Pre-Application

THE WASHINGTON STATE FAIR
**INTERNATIONAL
 VILLAGE**

INTERNATIONAL VILLAGE
 Washington State Fair
 Puyallup, WA

GROUND FLOOR

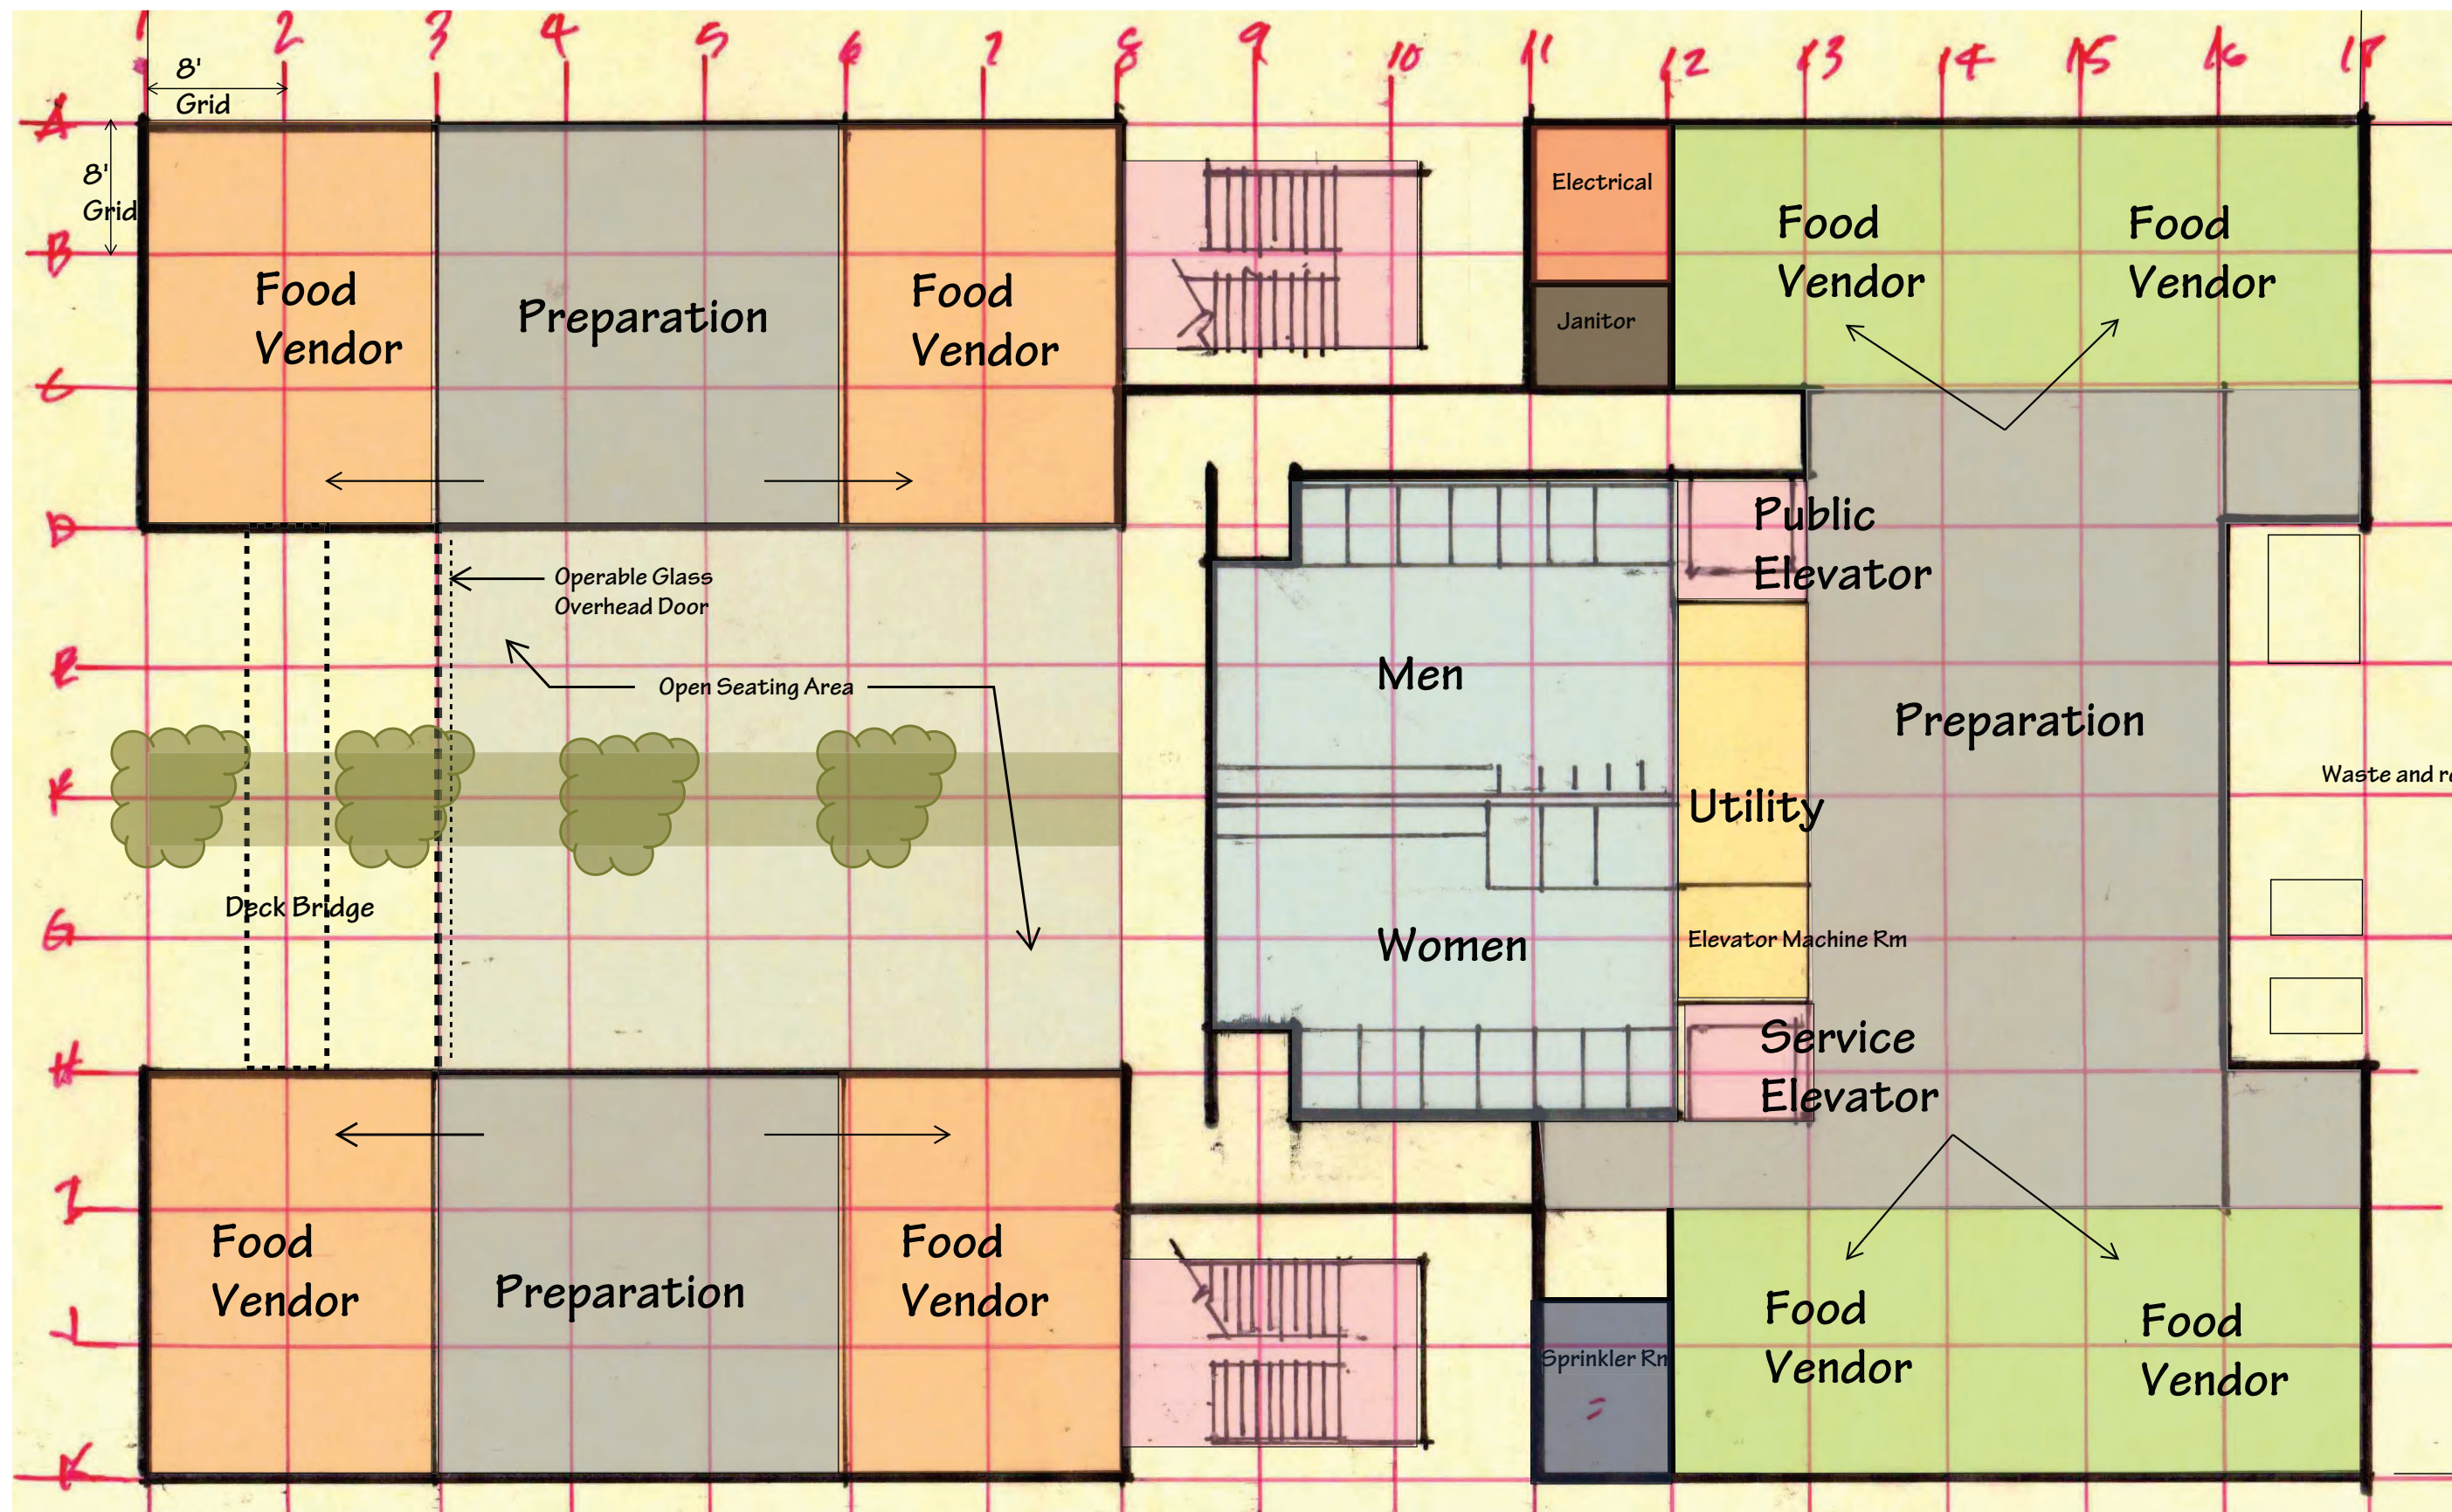
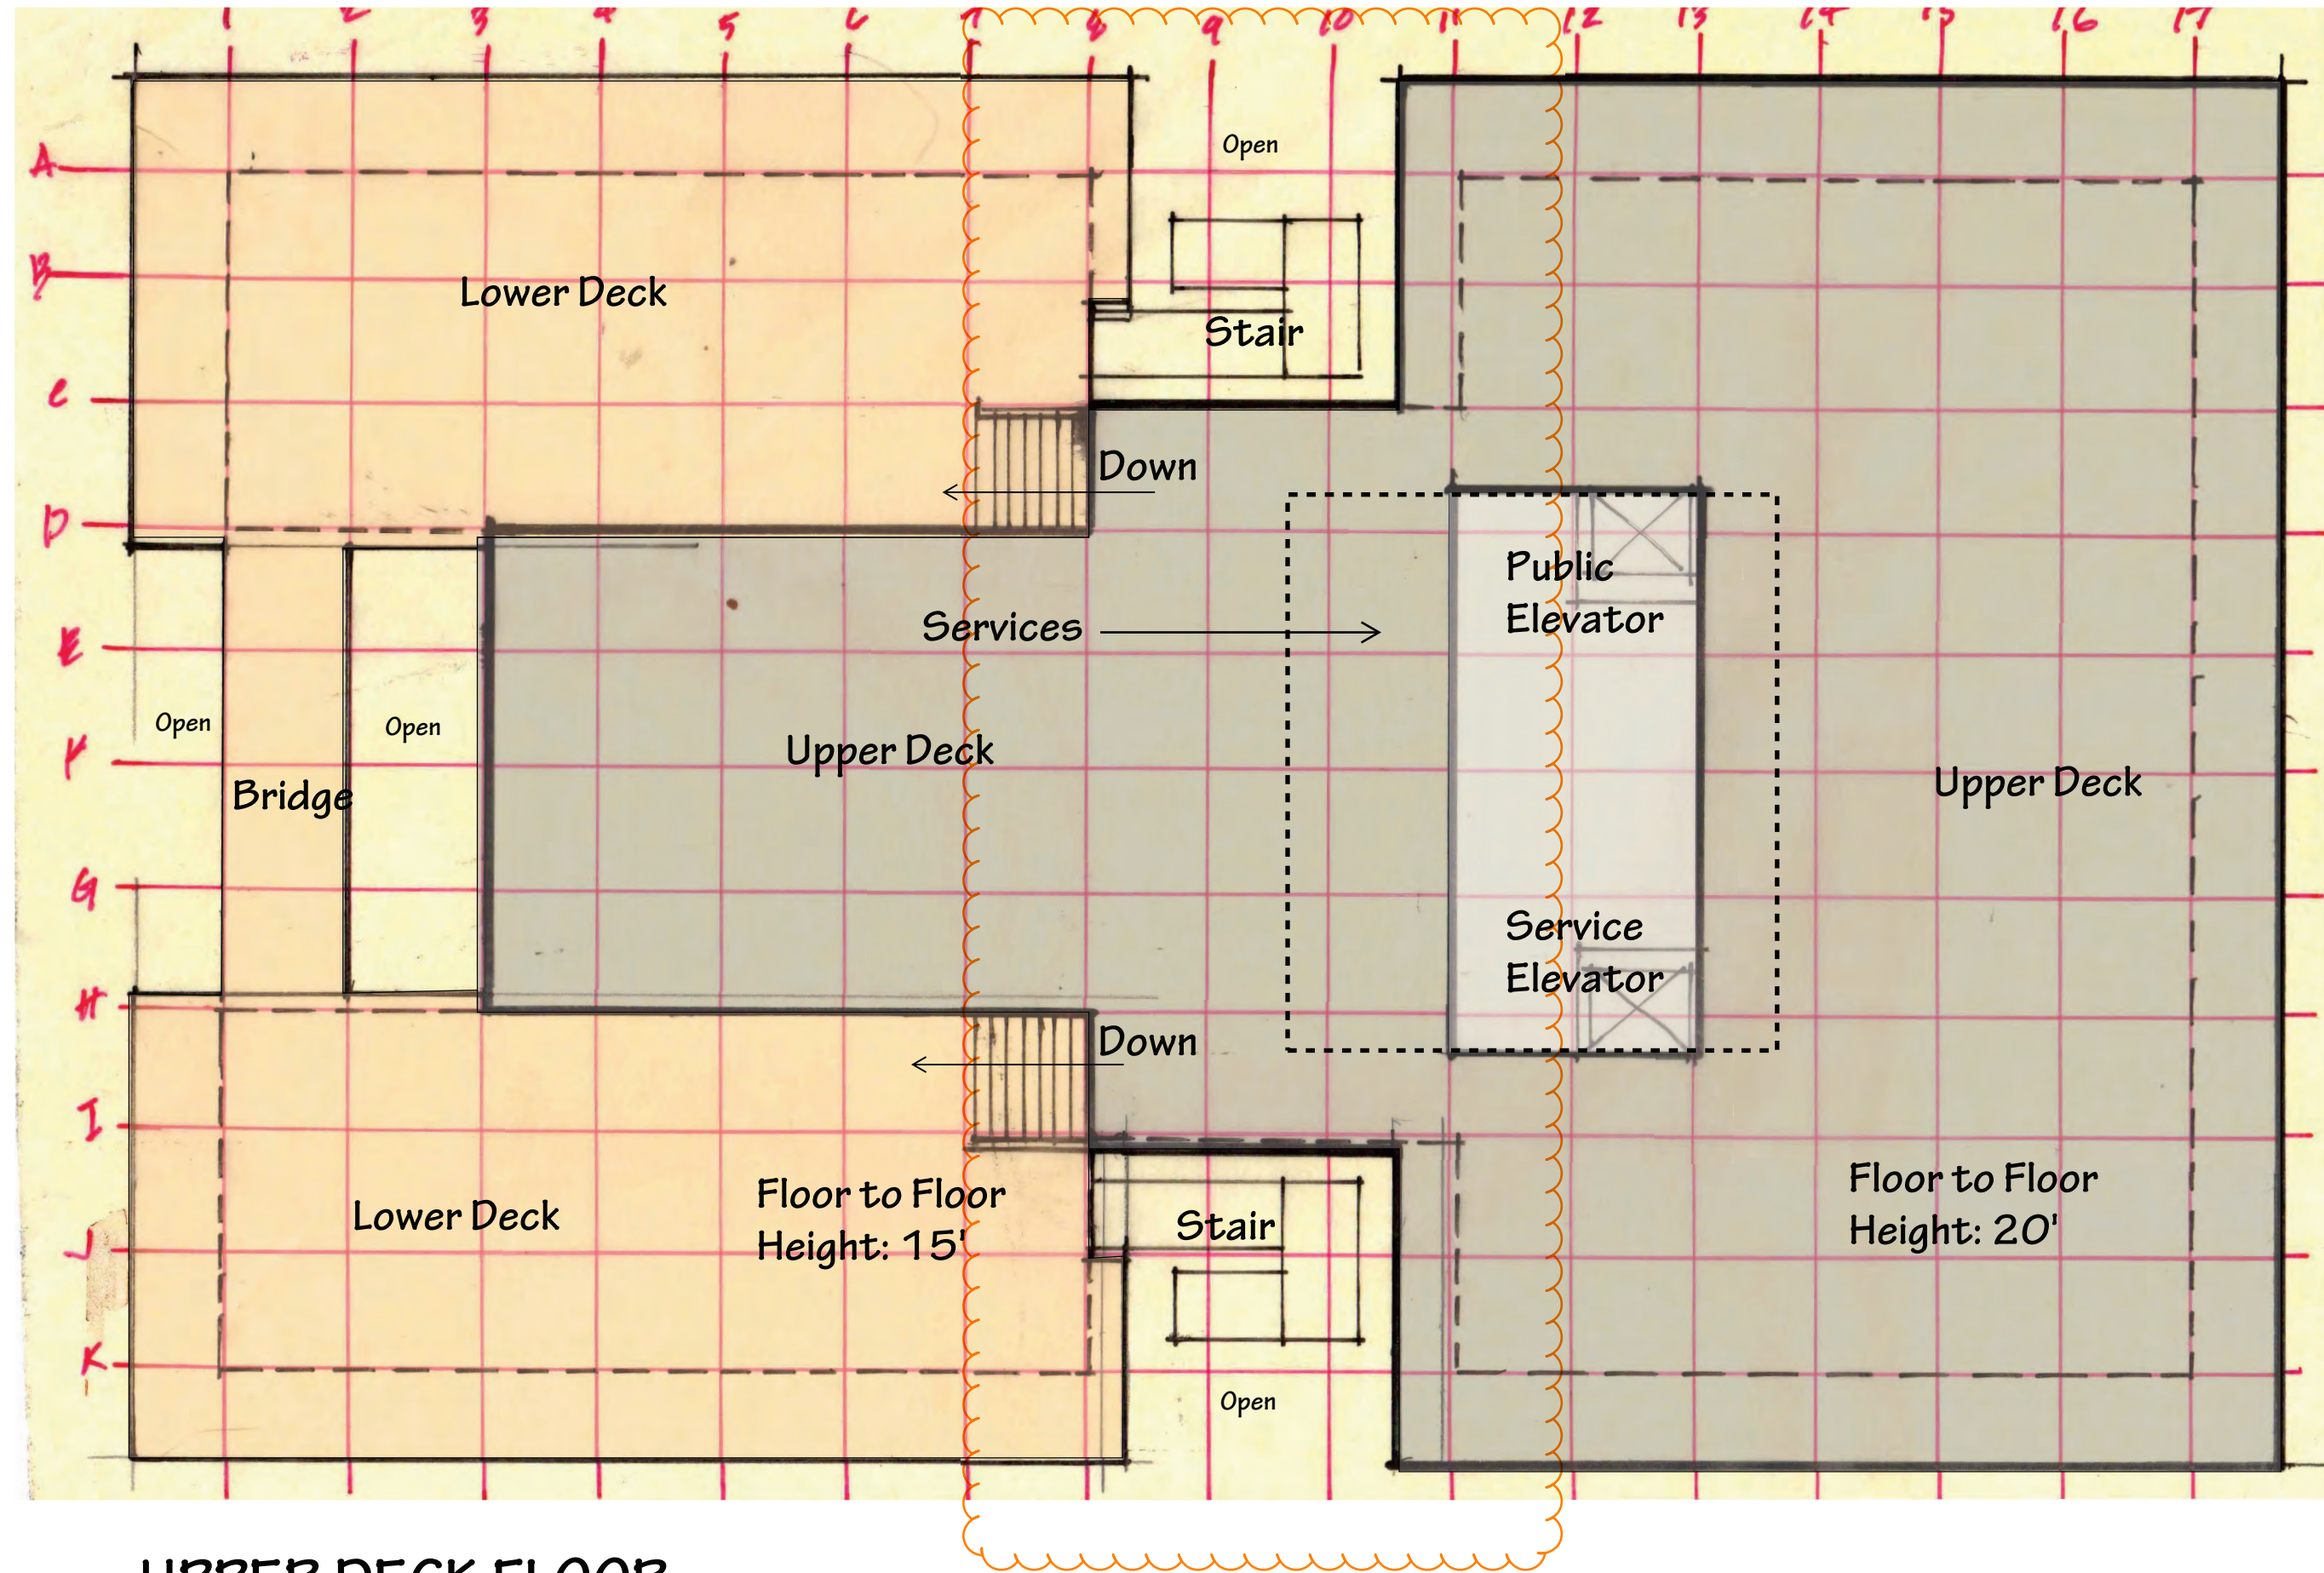
1007.1.1 Two exits or exit access doorways. Where two exits, exit access stairways or ramps, or any combination thereof, are required from any portion of the exit access, they shall be placed a distance apart equal to not less than one-half of the length of the maximum overall diagonal dimension of the building or area to be served measured in a straight line between them. Interlocking or scissor stairways shall be counted as one exit stairway.
Exceptions:
** 2. Where a building is equipped throughout with an automatic sprinkler system in accordance with Section 903.3.1.1 or 903.3.1.2, the separation distance shall be not less than one-third of the length of the maximum overall diagonal dimension of the area served.

***The proposed floor design does not appear to meet the egress separation requirement. Provide code path that supports current egress design for anticipated occupant load.
